Planning Commission Staff Report

Project Type:	Amended Site Development Plan
Meeting Date:	June 22, 2020
From:	Chris Dietz, Planner 
Location:	North of Olive Blvd. west of its intersection with North Woods Mill Road.
Description:	<u>13559 Olive Blvd. (McDonald's) ASDP:</u> Amended Site Development Plan, Landscape Plan, Lighting Plan, Architectural Elevations and Architectural Statement of Design for a 0.86-acre tract of land zoned "PC" - Planned Commercial District, located north of Olive Blvd. west of its intersection with North Woods Mill Road.

The Farnsworth Group, on behalf of McDonald's Corporation, has submitted a request for an Amended Site Development Plan, Landscape Plan, Lighting Plan, Architectural Elevations and Architectural Statement of Design for a fast food restaurant located on the north side of Olive Boulevard. The primary change within this request is to update the existing building to a modern design as part of a national branding effort. The request also includes changes to the site design with the addition of a second drive-thru lane, relocation of the trash enclosure, and minor parking reconfiguration.

Figure 4: Color Site Plan

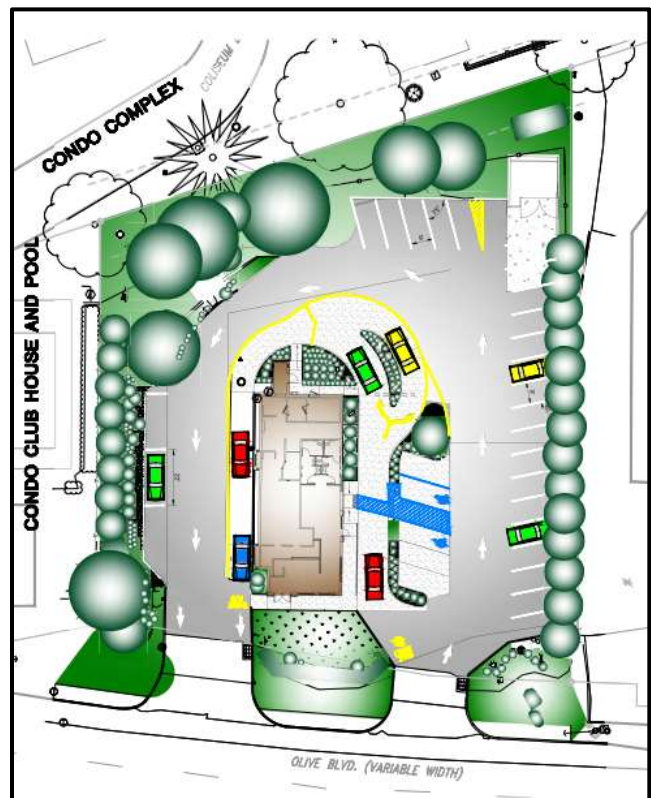
Parking will be reconfigured as part of this request to accommodate the dual drive-thru ordering stations. The proposed additional drive-thru lane is believed to alleviate parking demand and vehicle stacking by allowing more drive-thru customer traffic to be accommodated during peak hours. The site will be redesigned to include three (3) parallel

parking spaces on the west end of the site, offsetting the placement of the second drive-thru lane. The trash enclosure will also be relocated further north out of the parking area to further offset the placement of a landscape island just north of the two (2) ADA spaces. This request would result in no change to the amount of parking stalls (31) currently present on site.

When the site was first developed, the site's 31 spaces complied with the minimum parking standards for a development of this type. However, with the adoption of the current zoning code, the site has fallen into non-compliance since the UDC now requires a total of 40 parking stalls for the *restaurant-fast-food* use of this square-footage of floor area, as specified in code. As such, the site is considered an existing non-conformity. However, since this proposal is not reducing the number of physical parking spaces onsite, the non-conformity of parking is not being expanded. A formal request has been submitted for modification of standards for parking by reducing the minimum parking required for this site from 40 spaces to 31 spaces. Since the request results in a 22.5% decrease in minimum parking required, this request will require Planning Commission approval.

A parking demand study has been submitted by the applicant to supplement this modification of parking standards request, as required by code. The complete parking demand study is attached.
